MASTER DRAINAGE

LANDS OF RAY A. GRAHAM III

**RE: Grading and Drainage Plan for Lands of Ray Graham (E12-D154) Received  
October 1, 2001 and Letter dated January 28, 2002**

**RE: Master Drainage Plan for Lands of Ray A. Graham III (E12/D15), Engineer's Stamp  
Dated 4/12/99**

# EXHIBIT A-2

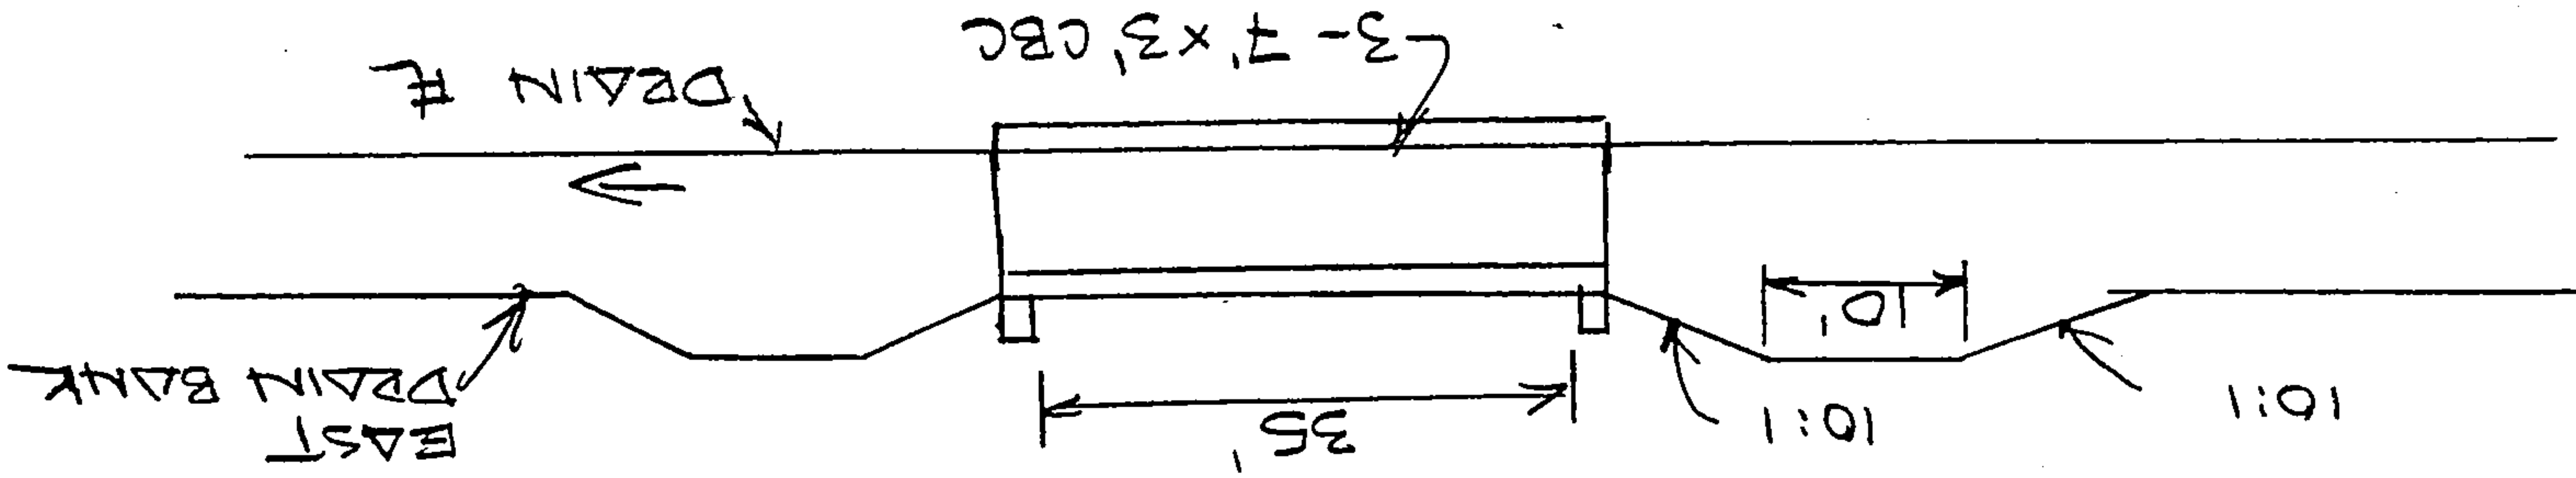
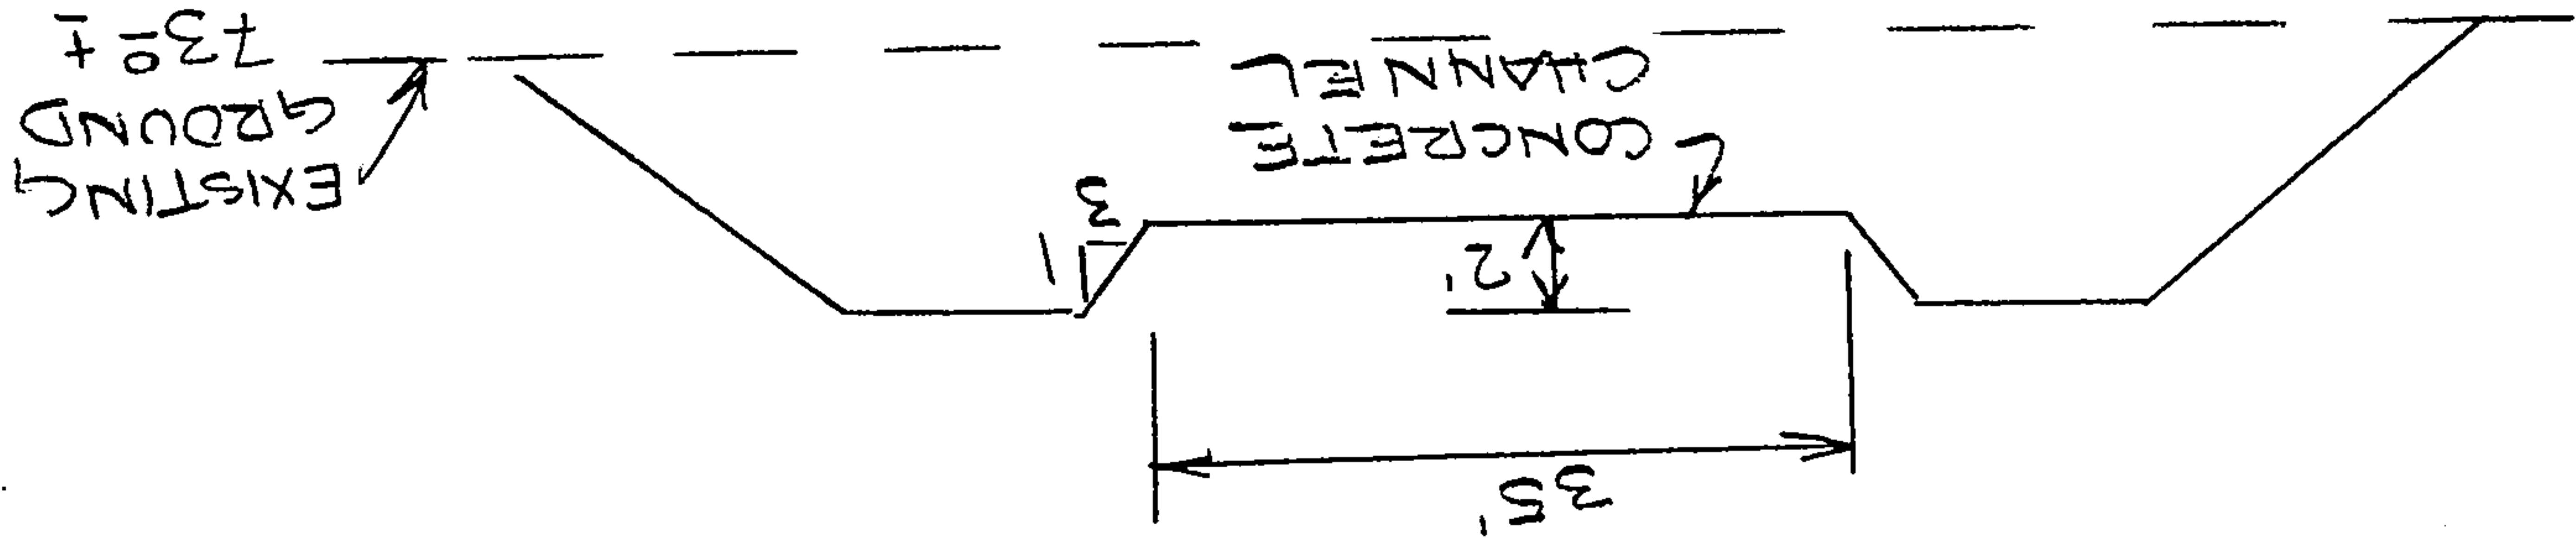
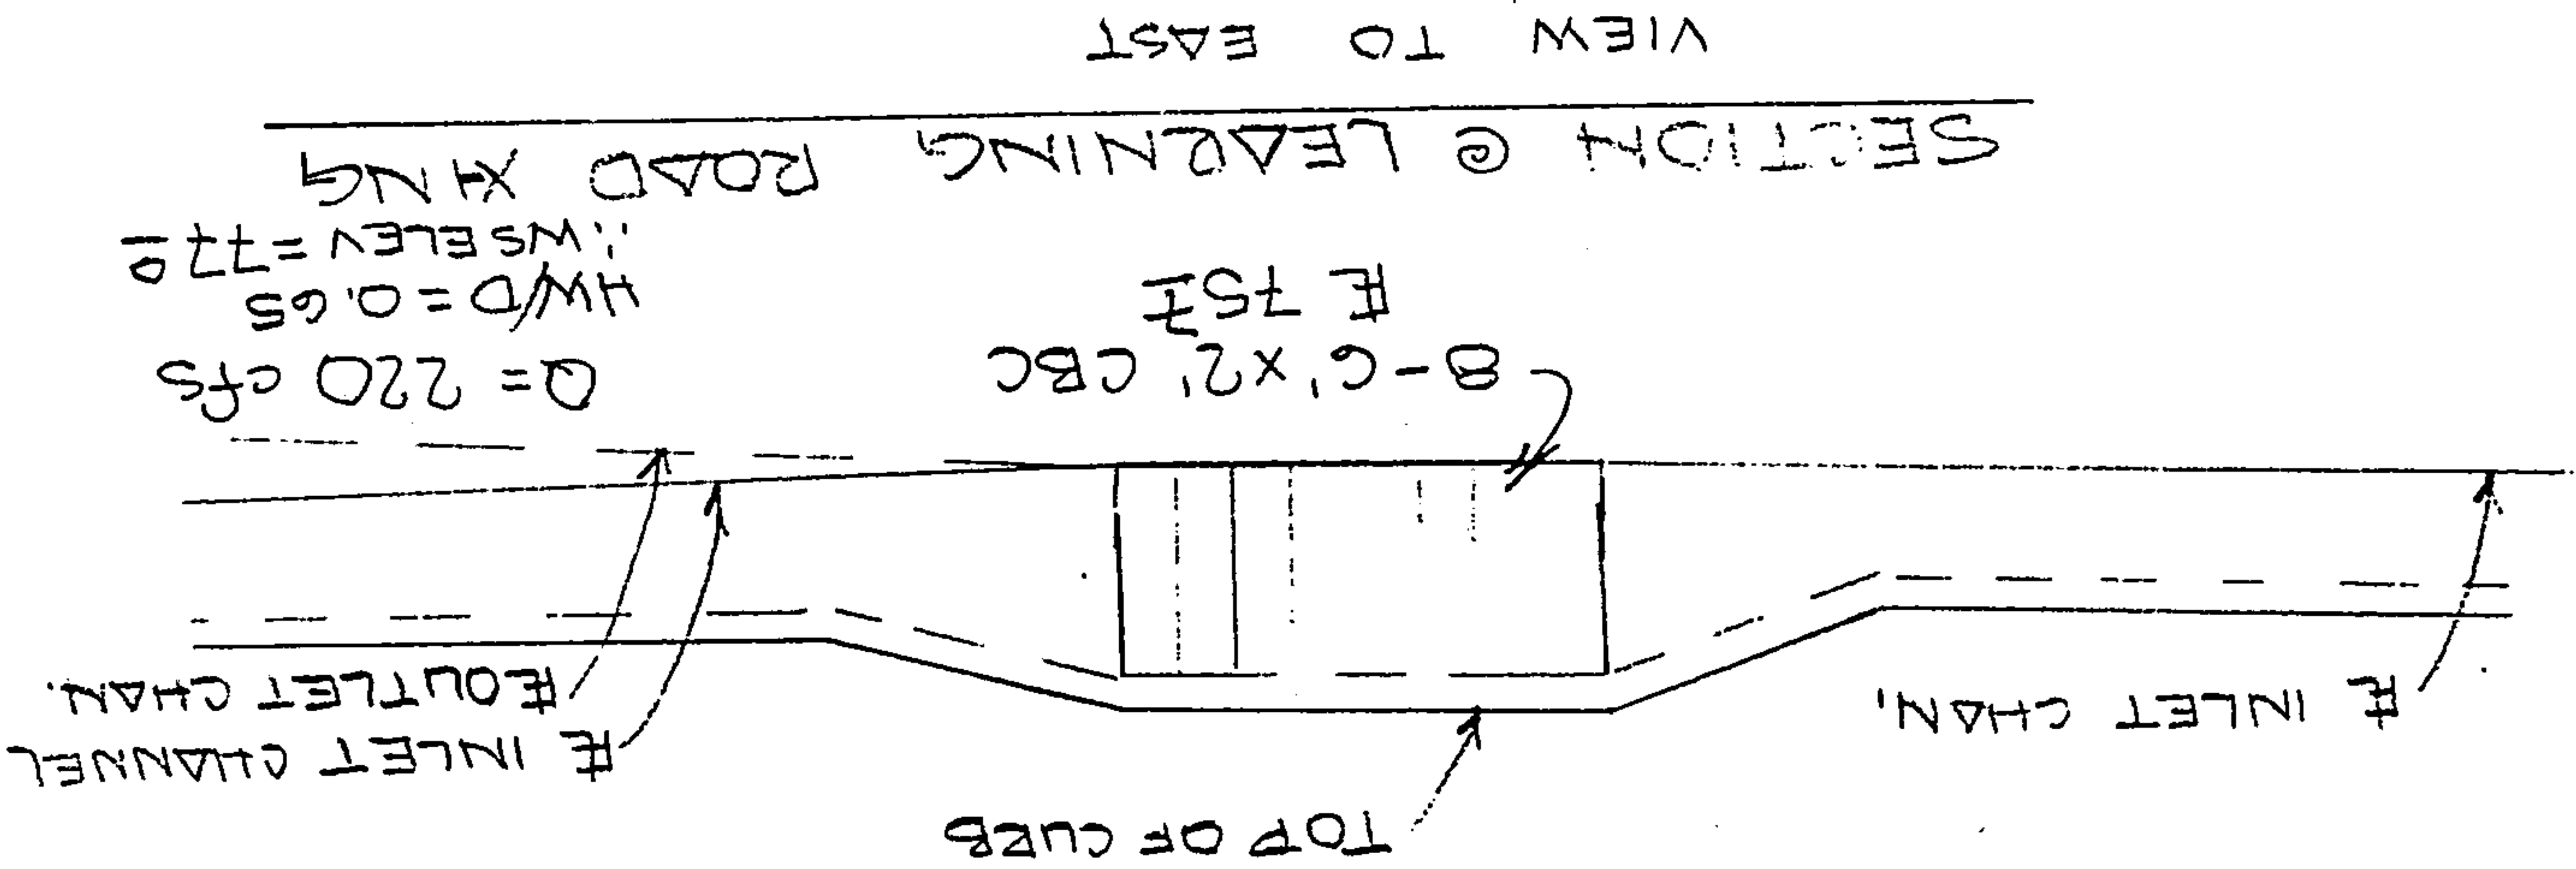
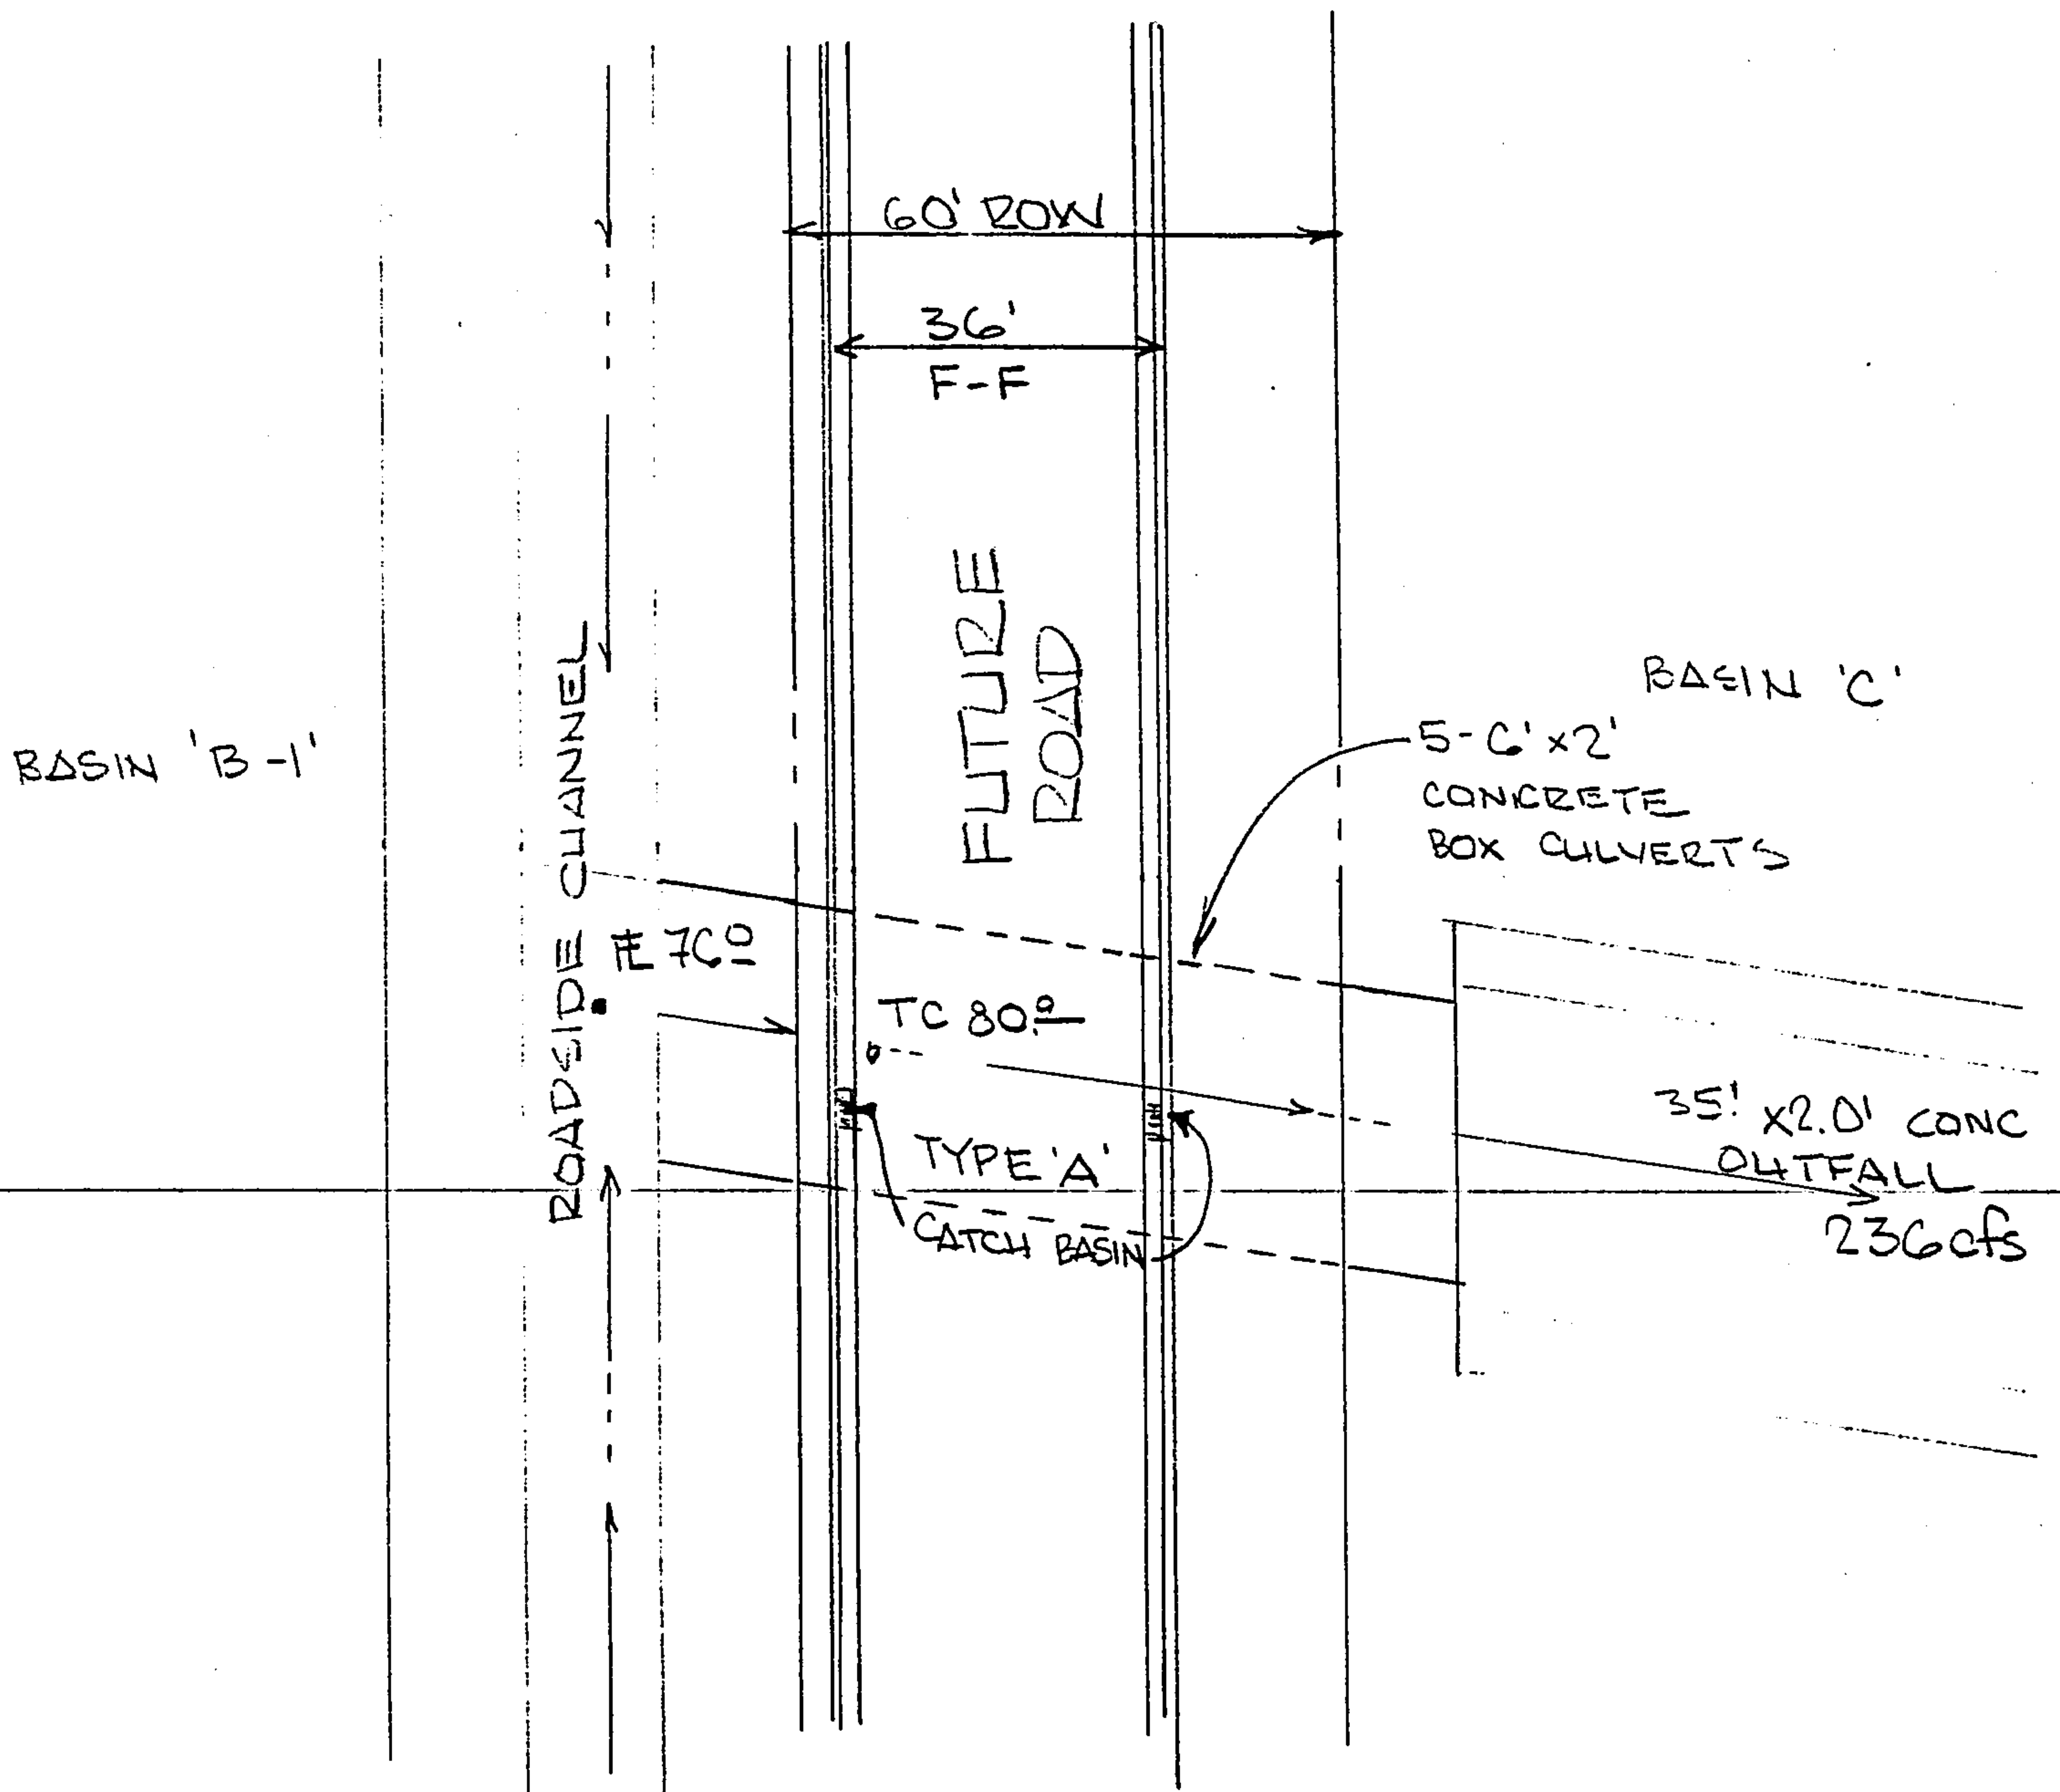
4. MRGCD concurrence will be required prior to development of Basins "C" or "D" for the concept of using the bank of the drain as the spillway.
5. The detail for the Basin "A" outfall is not acceptable. A sufficient design for the proposed street, culverts and roadside channel must be provided. Development of Basin "A" will not be allowed until a design of this outfall meeting the D.P.M. criteria is provided. The Basin "B" outfall must also be designed in detail prior to development of Basin "B."
